PROPRIETARY AND CONFIDENTIAL							SYSTEM:ALL TVP						
THE INFORMATION CONTAINED IN THIS DRAWING IS THE SOLE PROPERTY OF TELEMARK. ANY REPRODUCTION IN PART OR AS A WHOLE WITHOUT THE WRITTEN PERMISSION OF TELEMARK, IS PROHIBITED							Itemref	Quantity	REF			Date	Scale
							Designed by	Checked by	Approved by - date	File name	21/05/2012	DNS	
							I.BRINKLEY	-	-	.			
							TELEMARK					TVP_PT100_INTERFACE_BOARD	
							1801 SE COMMERCE						
BATTLE GROUND 98604									Edition	Sheet			
USA									B	1/1			
www.telemark.com													
17-04-02-01

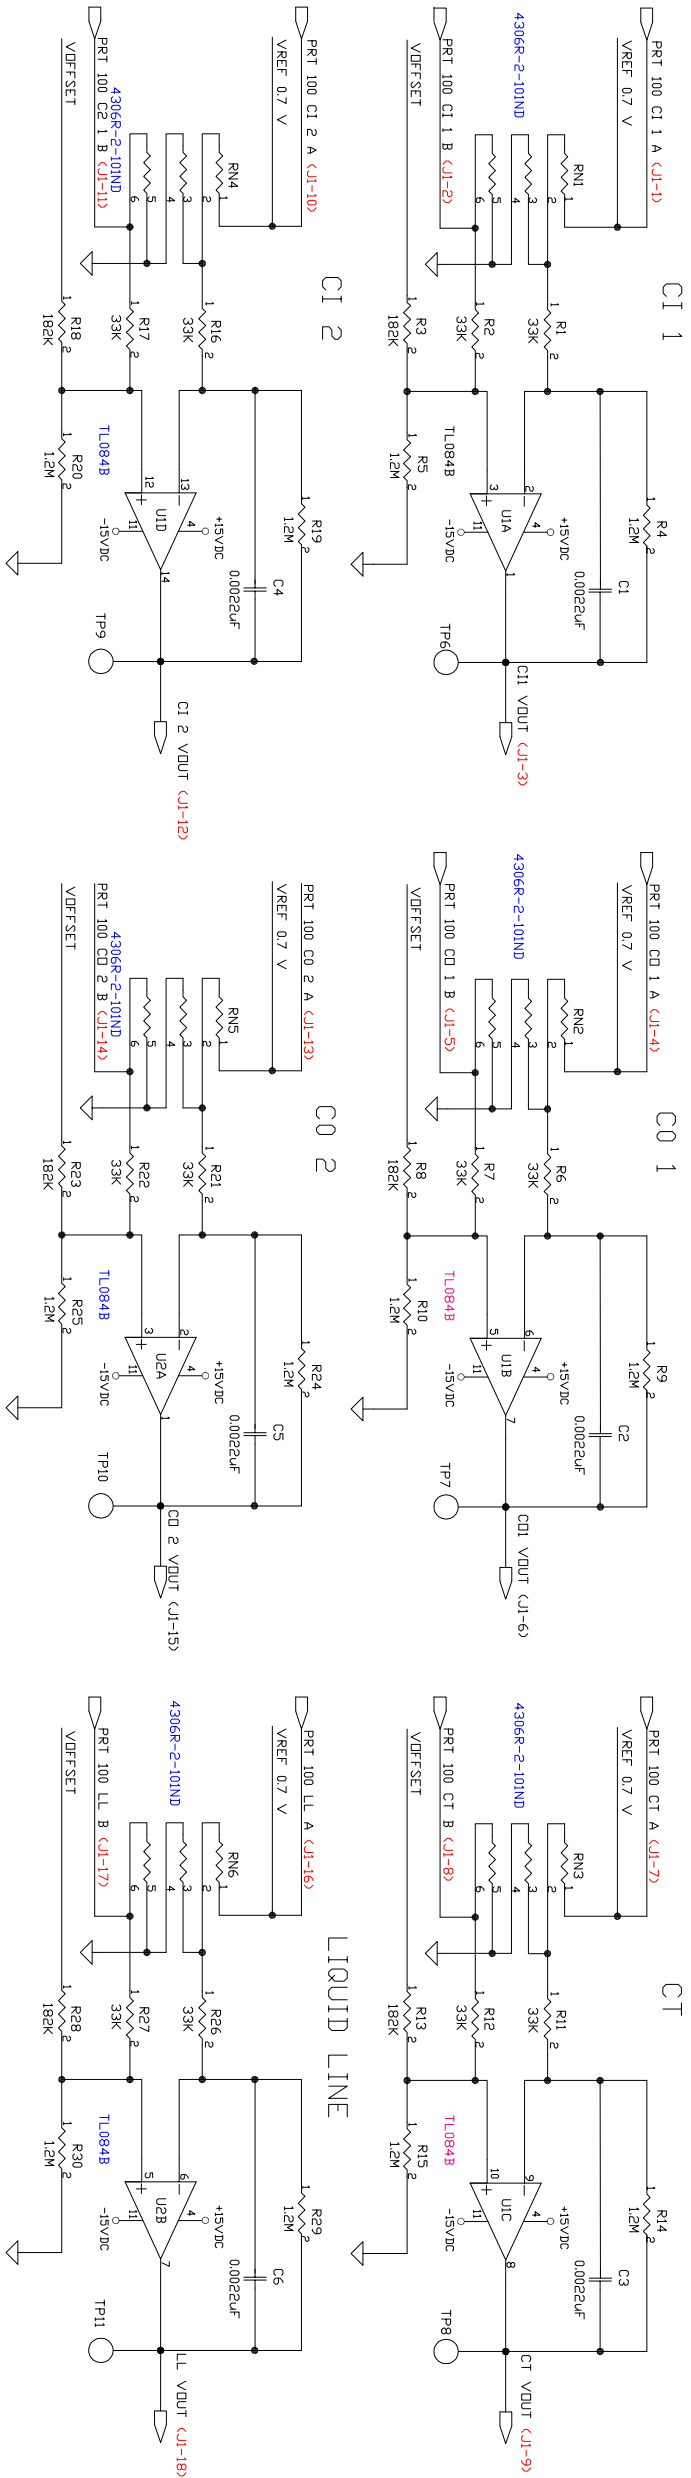
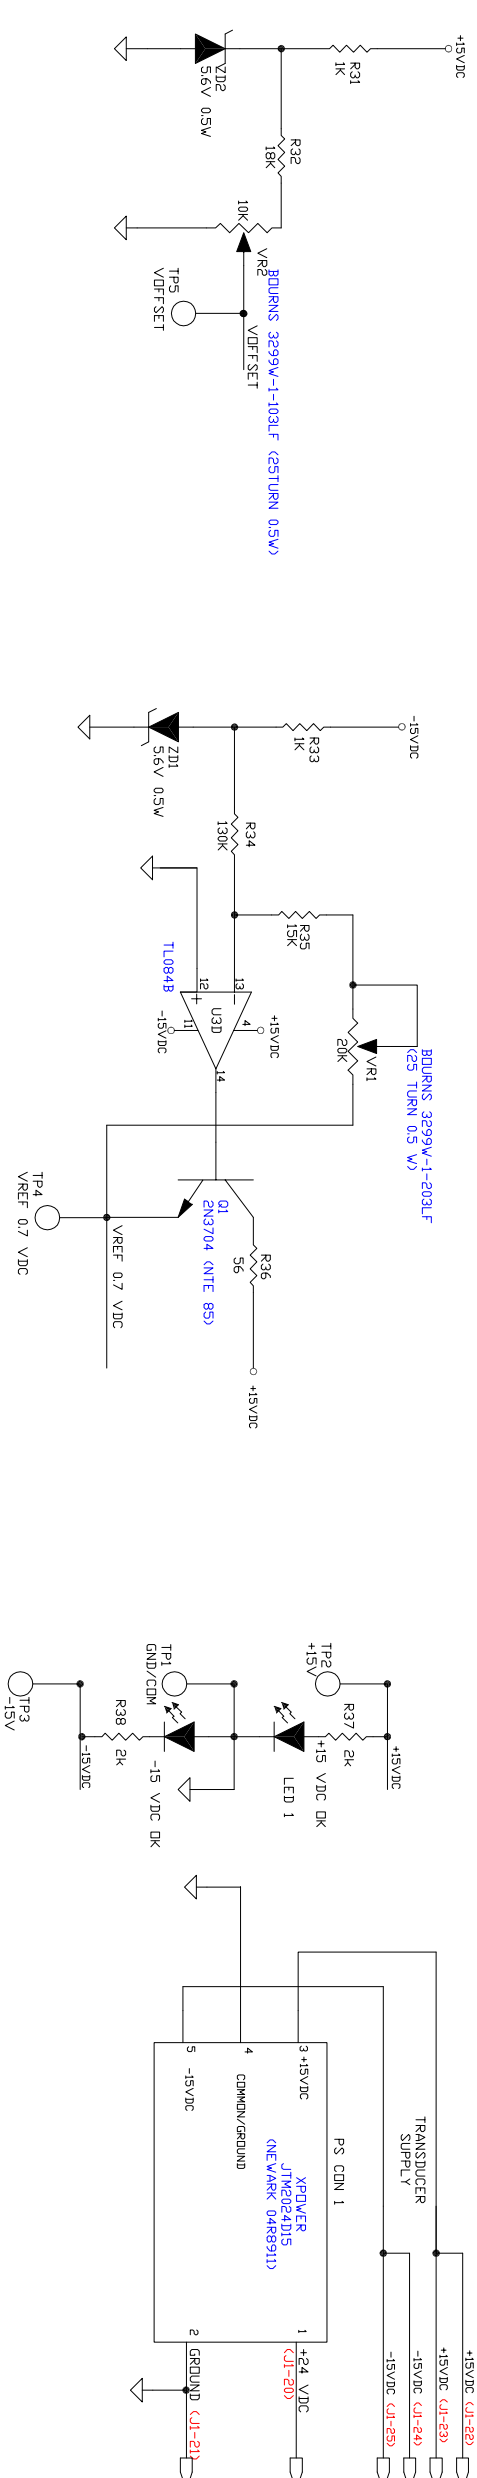
RevNo	Revision note	Date	Signature	Checked
A	Resistor number changes and R32 changed from 15K to 18K	9 JUL Y 2012		IB
B	remove R57, R60 & R63. Short R56, R59 & R62	30 Nov 2012		IB

NOTE: USE SHORT LINK ACROSS R56, R59 & R62
DO NOT FIT R57, R60 & R63
